EPA 542-R-13-006  
January 2013  
Office of Solid Waste and Emergency Response  
Office of Superfund Remediation and  
Technology Innovation

**Optimization Review**  
**Peck Iron and Metal Superfund Site**  
**Portsmouth, Virginia**

Report of the Optimization Review and  
Site Visit Conducted at the Peck Iron and Metal Superfund Site on  
February 22, 2012

January 18, 2013

## Figure 7 October 2008 Groundwater Potentiometric Surface

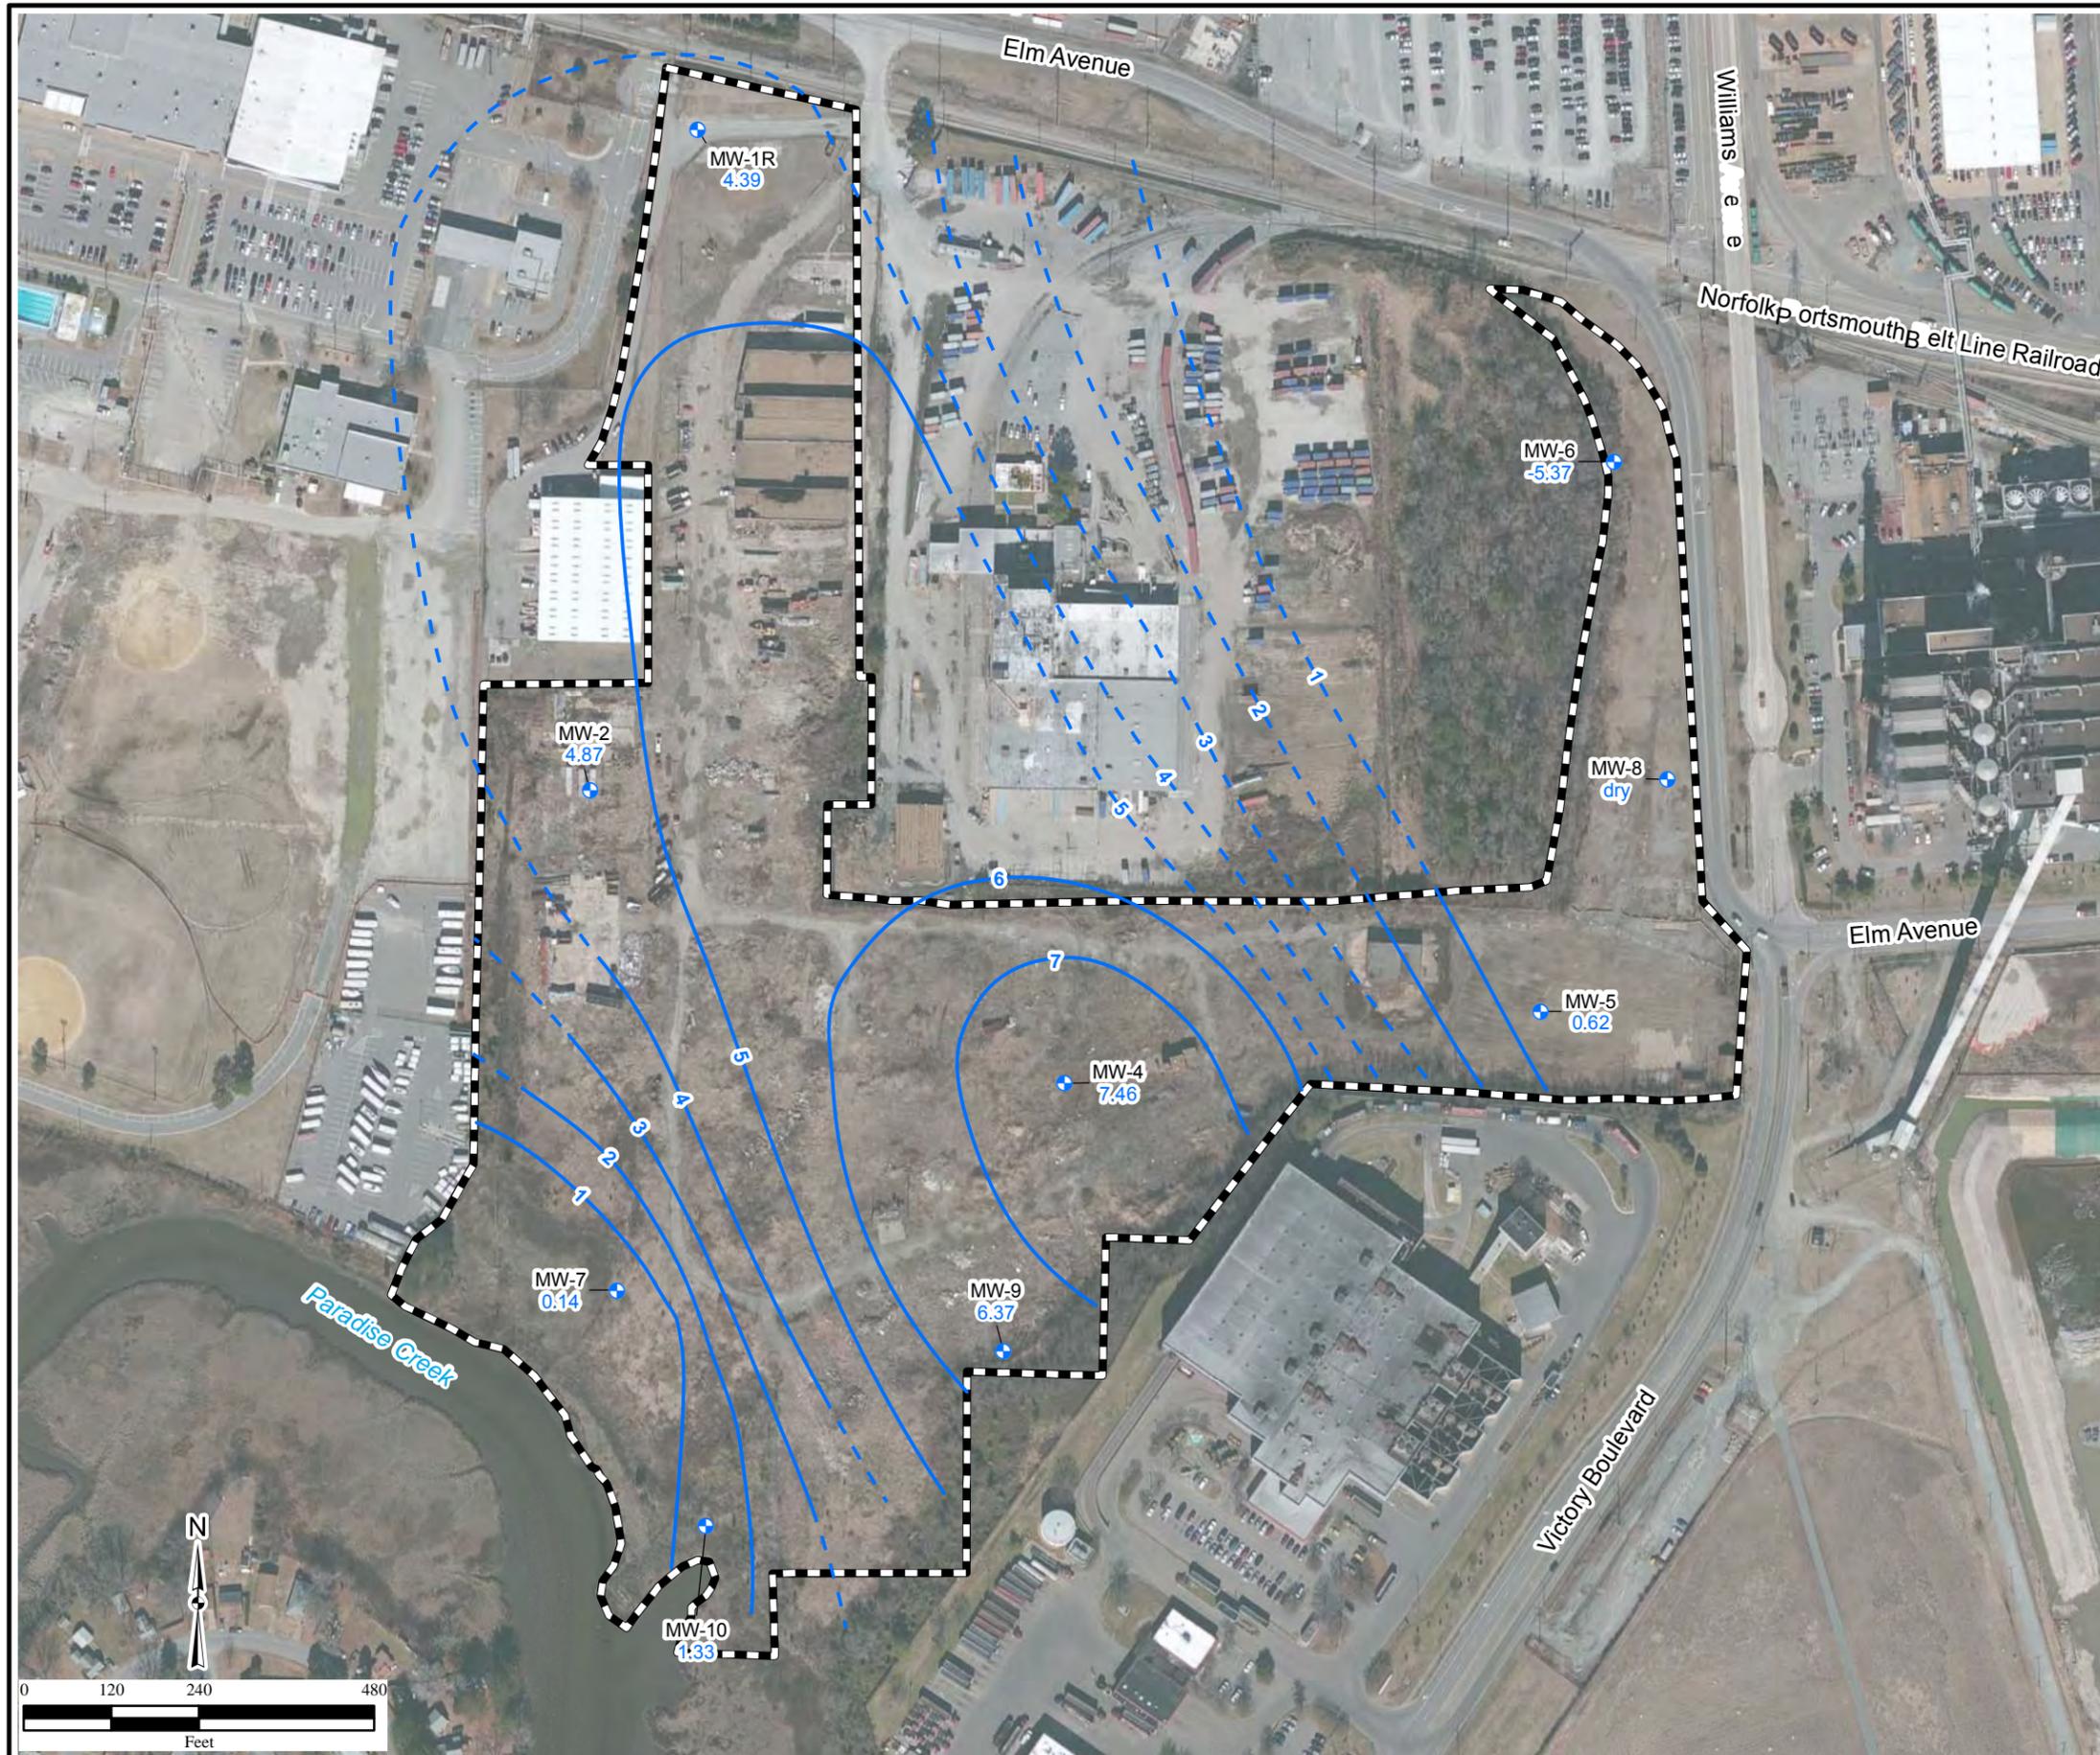
Figure 7 shows the water table elevation at the Site based on groundwater level data collected on July 24, 2008 (MPI, 2008). The water table ranged in elevation from -5.37 ft msl to 7.46 ft msl. To avoid an unaccounted for tidal influence in the measured groundwater levels, the data shown on Figure 7 were collected synchronously and thus are consistent with the ambient tidal level (MPI, 2008). The highest groundwater elevation was measured in monitoring well MW-4, located in the central portion of the Site where an apparent groundwater mound is present. From the apparent groundwater mound area, flow is generally southwestward toward Paradise Creek or northeastward toward the intersection of Elm Avenue and Williams Avenue. City utility maps indicate the presence of a storm drainage ditch paralleling Elm Avenue along the northern Site boundary and northern boundary of the ARREFF property. Near the northeastern corner of the Site, at the intersection of Elm and Williams Avenues, the ditch discharges to a southward flowing drainage pipe that parallels the eastern boundary of the Site. Drainage to the ditch and drain pipe may act to passively lower water levels in the eastern portion of the Site. Passive drainage alone, however, would only account for the lowering of groundwater to levels slightly greater than msl datum. The below sea level datum water levels consistently observed in MW-6 (-5.37 ft), if accurate<sup>2</sup>, suggest off-site influences on groundwater, such as pumping.

of toward the northeast, as shown on Figure 7. An improved understanding of groundwater flow direction is essential for accurate evaluation of the fate and transport of Site constituents in groundwater.

**Figure 8**  
**PCB Concentrations in Soils**  
**(0 to 18 inches bgs)**

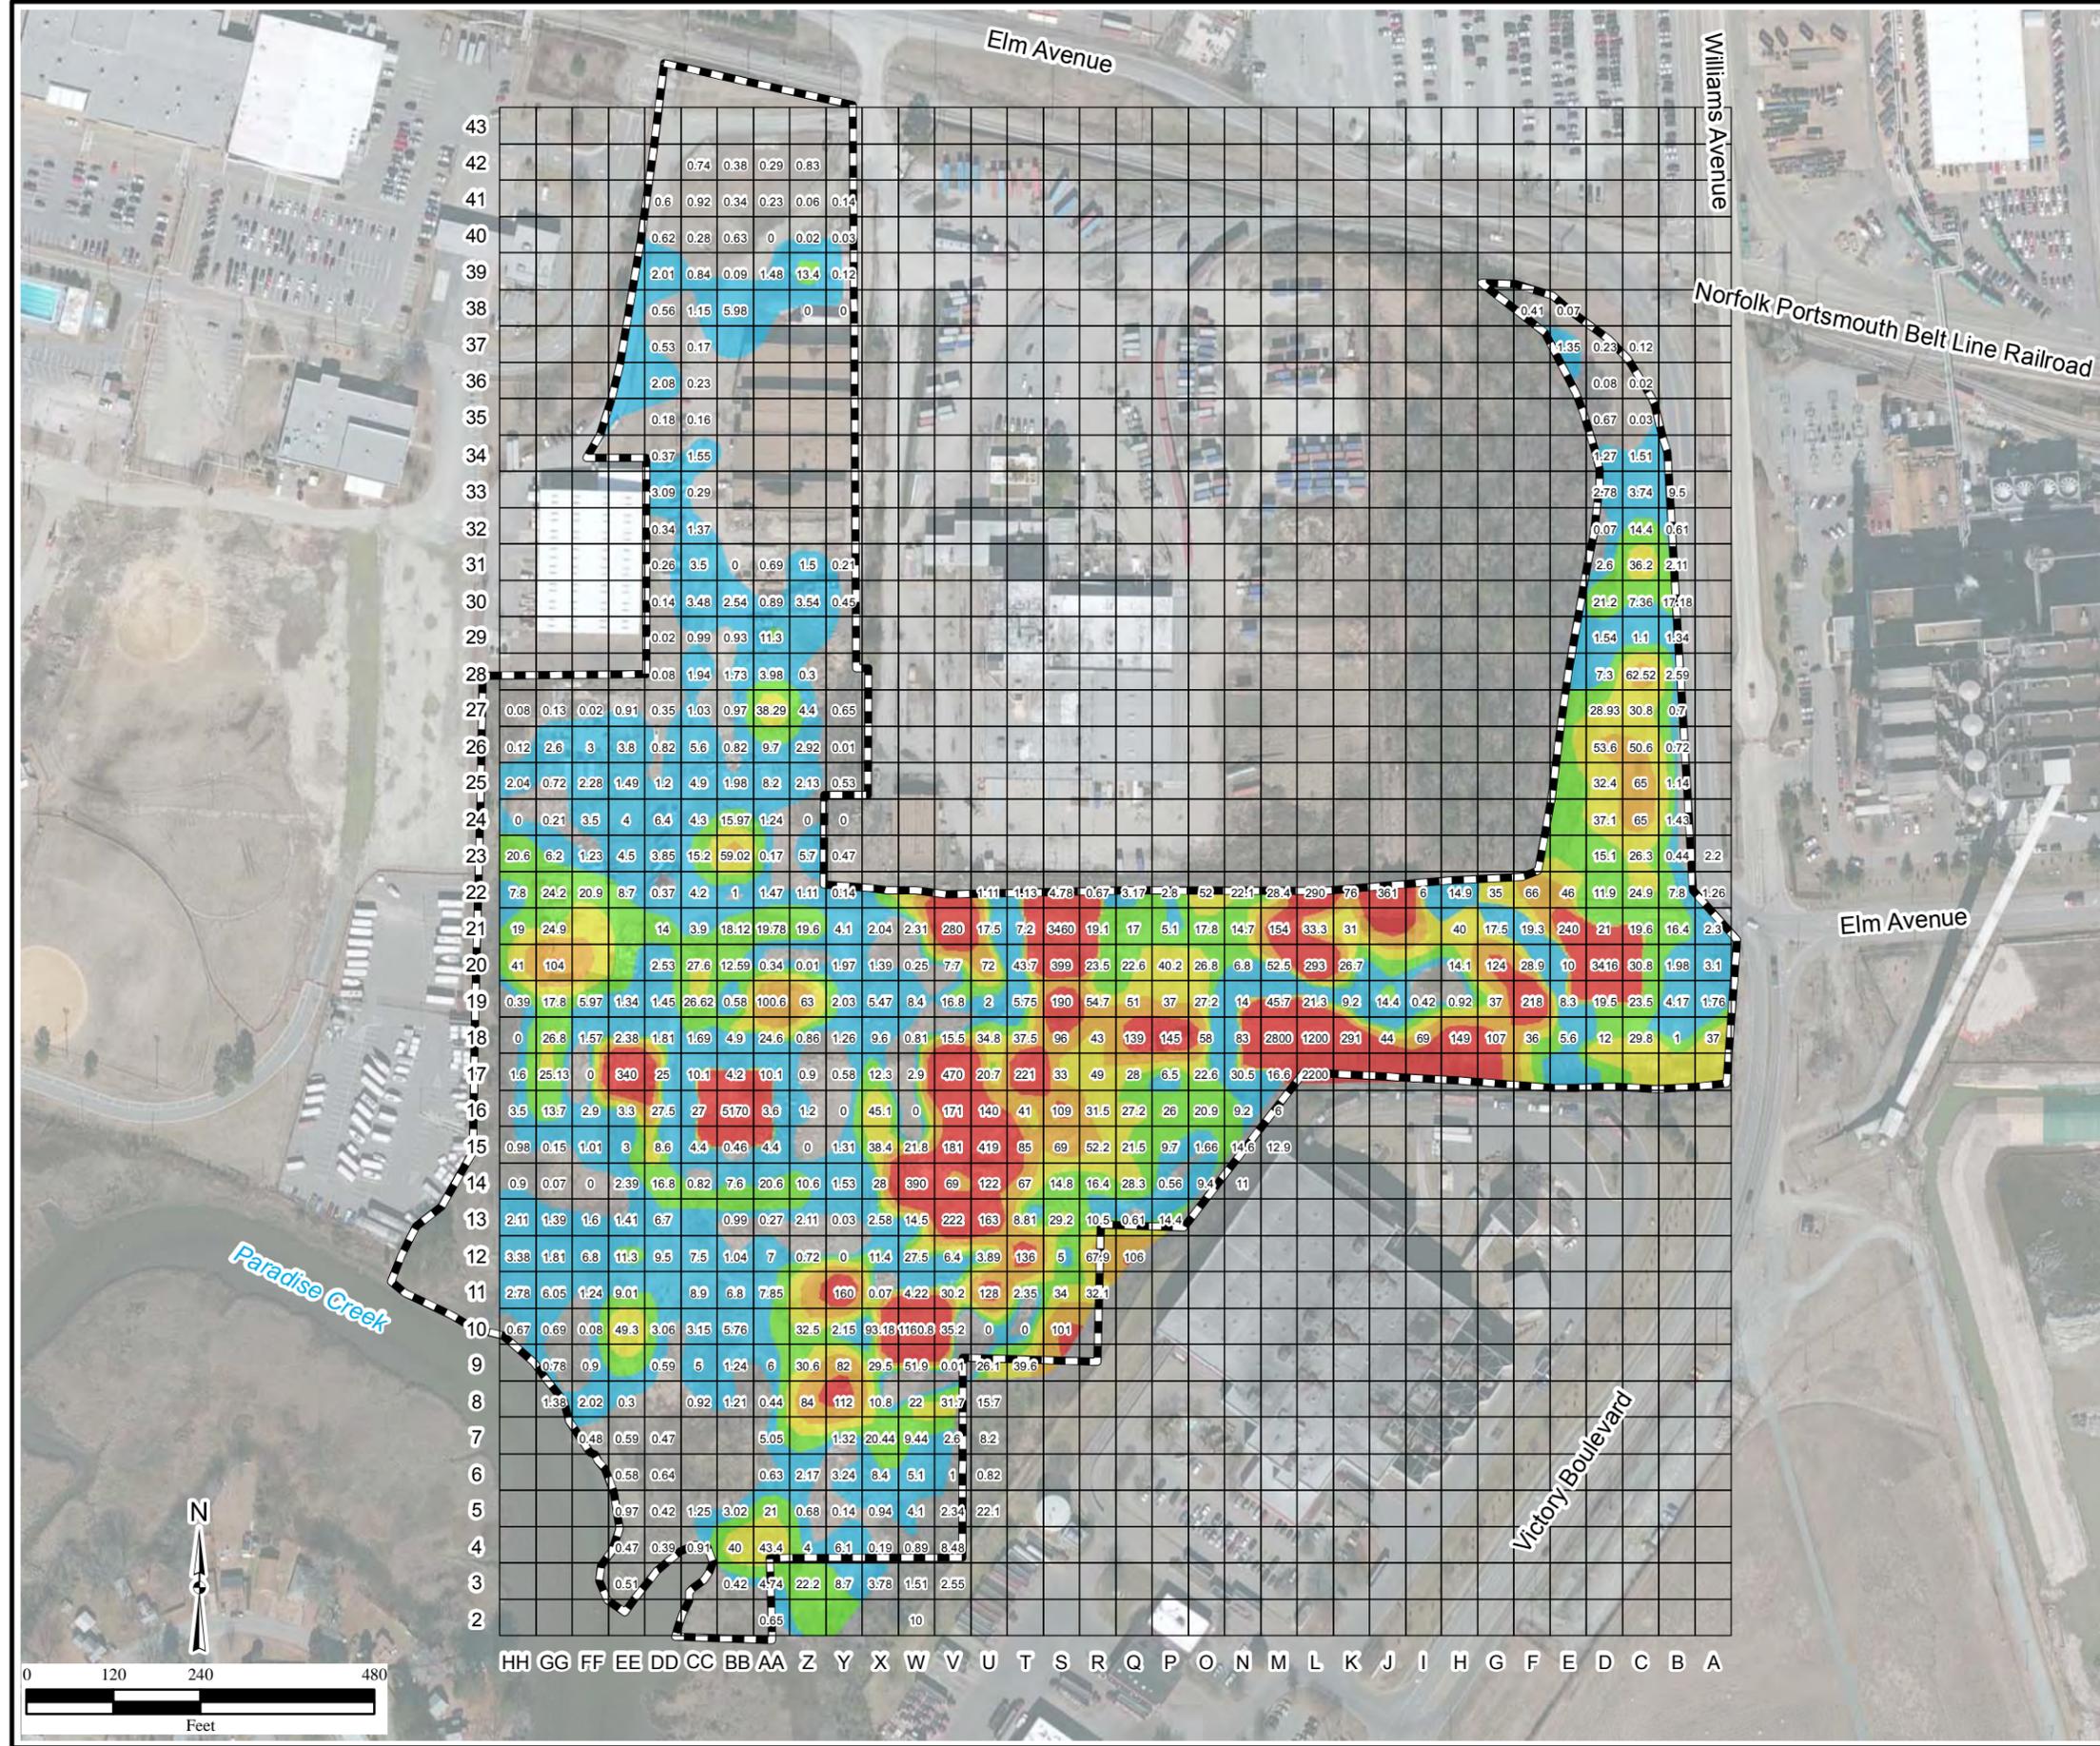
Figure 8 indicates that PCB concentrations in soils exceed 10 times the minimum PCB RSL (5.4 milligram per kilogram [mg/kg]) across most of the Site. In addition, arsenic, lead, mercury and nickel concentrations in soil are elevated Site-wide (Figures 9, 12, 13 and 14, respectively). Hotspots for these COCs exceed the industrial soil RSL by one or more orders of magnitude. PCB hotspots (>100 mg/kg) and lead hotspots (>8,000 mg/kg, 10 times the industrial soil RSL) occur in the central, eastern and northeastern portions of the Site. Arsenic hotspots (>160 mg/kg, 100 x industrial soil RSL) are distributed Site-wide. Mercury and nickel each exhibit one hotspot. The nickel hotspot (>20,000 mg/kg, 10 x industrial RSL) is located on the Site’s western boundary, at a point along the western drainage. The mercury hotspot (>43 mg/kg, 10 x industrial RSL) is located adjacent to the Paradise Creek shoreline.

Figure 8 shows PCB concentrations measured in surface soil. Because the minimum contour defines PCB concentrations of 1 mg/kg or greater (compared to a screening level of 0.1 mg/kg), all shaded areas shown on the figure exceed the PCB screening level. Review of the non-shaded areas (PCB concentrations below 1 mg/kg) reveals that, with only a few exceptions, all non-shaded grid blocks with a posted concentration also exceed the lead screening level. Two or more contiguous grid cells with less than screening level posted concentrations include several areas in the northwest portion of the Site (Y40-AA40 and Y38-Z38) and the south-southwestern portion of the Site (Y24-Z24, FF14-HH14, Y16-Z15 and T10-U10).
